STAFF REPORT
COMMUNITY DEVELOPMENT DEPARTMENT

HEARING DATE: 7/12/2022
 TO: Mayor & City Council
 FROM: Joseph Dodson, Associate Planner
 208-884-5533
 SUBJECT: H-2022-0035
 Centrepointe Mixed-Use MDA
 LOCATION: Project is located at 3030 N. Cajun Lane and 3100 N. Centrepoint Way, near the southwest corner of N. Eagle Road and E. Ustick Road, in the NE 1/4 of the NE 1/4 of Section 5, Township 3N, Range 1E.

Request to modify the existing development agreement (Villasport, Inst. # 2019-060877) for the purpose of updating the concept plan and provisions to construct a mixed-use development consisting of commercial space and a multi-family development in lieu of an athletic club/spa and commercial building on 11.17 acres in the C-G zoning district, by Givens Pursley.

**Site Plan-Overall**
NOT TO SCALE 1" = 50'

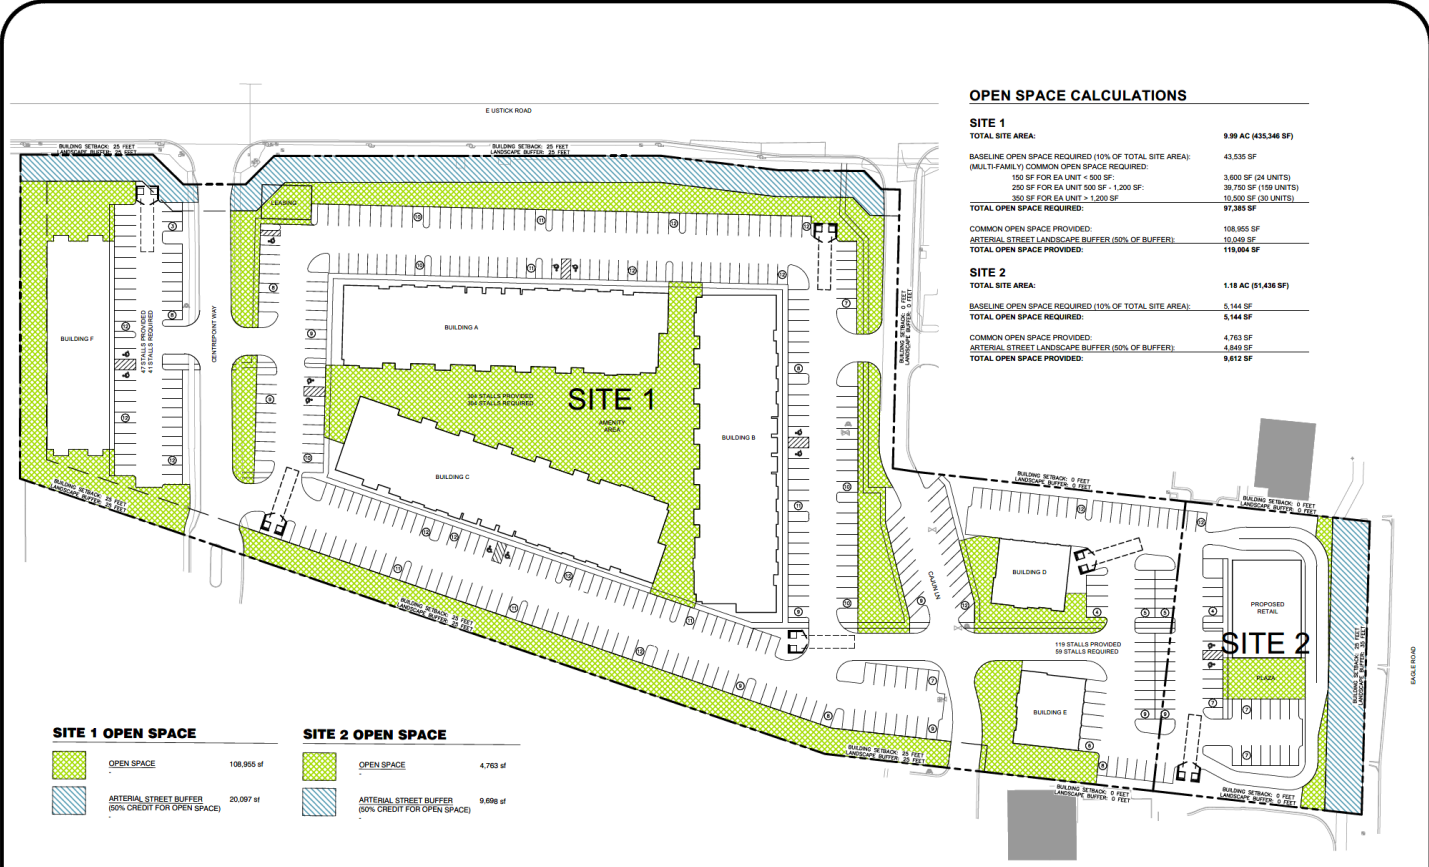
The submitted concept plan (Exhibit VI.B below) depicts five (5) multi-family buildings with internal access (not garden style apartments) and two commercial buildings—the multi-family is split into three (3) 4-story buildings on the larger area of the site west of the Cajun Lane and two (2) 3-story buildings between the two commercial buildings Cajun Lane. The submitted plan depicts at least a 25-foot landscape buffer along the entire perimeter of the site except for the southeast area of the site that abuts commercial uses. Further, it appears no building is proposed within 150 feet of the existing residences to the south of the site and includes the 25-foot buffer, carport parking, a drive aisle, and surface parking between the proposed 4-story apartment buildings and the existing homes. For comparison, Villasport was approved approximately 65 feet from the existing homes. Staff finds this separation should significantly help mitigate any issues with the height disparity of the existing two-story homes to the south and the proposed 4-story buildings. The Applicant has provided a perspective drawing from the intersection of Centrepoint and E. Picard looking northeast to help show the view from the street (see section VI.B).

Overall, Staff finds the proposed layout to be an efficient use of the space for the proposed multi-family use and provides for the safest access available. However, Staff does have concerns with the viability of the proposed open space to meet code requirements and the design of the southeast portion of the site. According to the specific use standards for multi-family development (UDC 11-4-3-27), common open space may not be counted towards the required minimum when it is adjacent to arterials unless approved through the CUP process. Therefore, the proposed open space shown may not all be qualified open space if Planning and Zoning Commission do not approve it in its current location. This is concerning because if the Commission does not approve it, the proposed site plan and open space will not comply with the minimum open space standards and major revisions would likely be needed or a relatively major reduction in units would need to occur to reduce the amount of qualified open space needed.

Staff's other main concern is in regards to the southeast area of the project that depicts two commercial buildings and two multi-family buildings. The required landscape buffer to Eagle Road is 35 feet and the concept plan depicts a 25 foot buffer instead. In addition, the color concept plan depicts the multi-use pathway segment required within this buffer to be completely out of alignment with the two existing segments to the north and south. Because the design for the commercial and drive-through is shown to be directly abutting the 25-foot buffer, the Applicant will need to shift the entire commercial site west at least 10 feet to comply with UDC requirements. Furthermore, the Applicant will need to extend the multi-use pathway from the existing locations on their north and south boundary and place this pathway within the landscape buffer and not within ACHD right-of-way as currently shown.

1. Increase the Eagle Road buffer from 25 feet to 35 feet to comply with the UDC.
2. Continue the multi-use pathway in alignment with the existing locations stubbed to the north and south property lines.

3. Continue the pedestrian network shown along the southern boundary to connect from the west half of the site to the multi-use pathway along Eagle and provide for a connection from the commercial building sidewalks, consistent with code.

4. Remove one or both of two 3-story multi-family buildings or reduce their size to a point that allows more commercial space, more parking, and a plaza that can be more directly shared between the 3-story multi-family buildings and the commercial or the 4-story multi-family and the commercial—there are a number of ways this could be accomplished but Staff is recommending the following:

- a. Remove building D in lieu of a larger shared plaza in its location.
 - b. Reduce or remove the plaza area currently shown as the noise and smell from the Eagle Road traffic largely reduces the appeal of outdoor seating along this corridor.

- c. Increase the size of the retail building for added commercial space.

In addition, there are a number of parking spaces proposed west of Centrepoint Way with no other development on this area of the site. In order for future residents to use this parking lot they will need to cross Centrepoint Way which would be anticipated as a busy roadway with the existing residences and the addition of the proposed multi-family. Staff has concerns over the safety of access to this parking lot. Centrepoint Way is public right-of-way so if any crossing is proposed, the Applicant would need to work with ACHD to obtain approval to modify the intersection depicted on the concept plan. **Staff supports the inclusion of bulb-outs and striping at a minimum in order to**

1. Future development of this site shall be substantially consistent with the submitted concept plan and color renderings included in Section VI and the provisions contained herein.

4. The required landscape street buffers and multi-use pathway segment shall be constructed and vegetated with the first phase of development along E. Ustick Road and N. Eagle Road; the proposed 25-foot landscape buffer along the west and south boundaries shall be constructed with the first phase of development.

5. Applicant shall work with ACHD to construct a safe pedestrian crossing from the multi-family site area to the parking lot along the west boundary across N. Centrepoint Way.

- ~~6. Prior to the City Council hearing, revise the site plan generally consistent with Staff's recommendations in Section IV.~~
7. With the future Conditional Use Permit for the multi-family development, the building along the west boundary shall be no more than two-stories in height and the three (3) buildings within the center of the project shall be no more than three-stories in height, consistent with the Applicant's revised concept plan and presentation to Council.

8. Applicant shall continue the masonry wall along west property boundary consistent with adjacent development and to help buffer the proposed project.

9. Staff and Applicant shall work with ACHD to mark Centrepoint Way as no-parking on both sides, should ACHD allow it.
